# Access Compliance Report

## Public Rights-of-Way

Intersection ID: 10037212	Main Street: SANDY_ROCK_PL	Cross Street: N/A	Location: SE
ADA ID: D731207A4A4D	Ramp Type: Perp	Initial Pass/Fail: Pass	Overall Compliance: No
Severity Score: 0.25			
Codes/Mitigation Info/Possible Solution		Field Measurements/Component Compliance

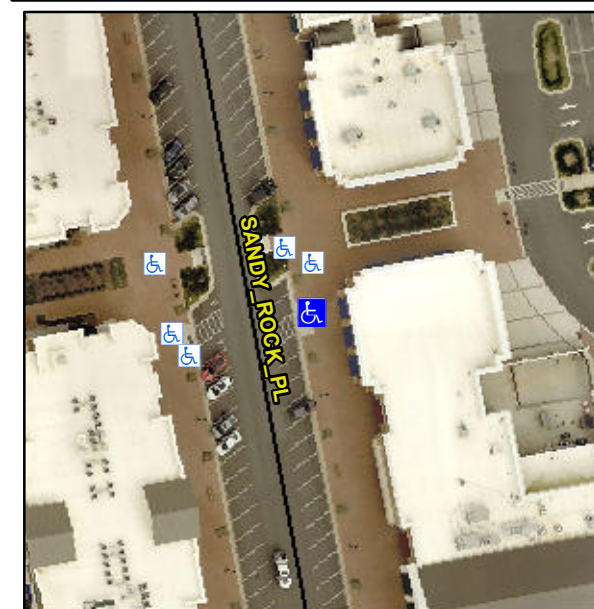
**Not Found, R304.5.3**

Compliance	Description	Data	Compliance	Description	Data
N/A	Ramp Length (in)	84.0	Yes	Ramp Slope (%)	6.3
Yes	Ramp Width (in)	60.0	No	Ramp XSlope (%)	2.1
N/A	Flare Type LT	Sloped	N/A	Flare Type RT	N/A
N/A	Flare Slope LT (%)	6.7	Yes	Flare Slope RT (%)	6.3
N/A	Flare Traversable LT?	Yes	N/A	Flare Traversable RT?	Yes
Yes	Landing Length (in)	60.0	Yes	DWS Provided?	Yes
Yes	Landing Width (in)	60.0	Yes	DWS Contrast?	Yes
Yes	Landing Slope (%)	0.6	Yes	DWS Length (in)	24.0
Yes	Landing X Slope (%)	0.9	Yes	DWS Full Width?	Yes
N/A	Landing Curb? (Y/N)	No	Yes	DWS Offset (in)	0.0
N/A	Shared Landing?	No			
Yes	Gutter Ponding?	No	Yes	Gutter Slope (%)	4.5
Yes	Gutter Lip Ht (in)	0.0	No	Gutter X Slope (%)	2.3
N/A	Painted X Walk1?	No	N/A	Painted X Walk2?	N/A
	X Walk 1 Direction	To W		X Walk 2 Direction	N/A
N/A	X Walk 1 Width (in)	N/A	N/A	X Walk 2 Width (in)	N/A
	X Walk 1 Slope (%)	2.8		X Walk 2 Slope (%)	N/A
	X Walk 1 X Slope (%)	2.0		X Walk 2 X Slope (%)	N/A

**Remove & Replace Entire Ramp.  
Remove & Replace Gutter.**
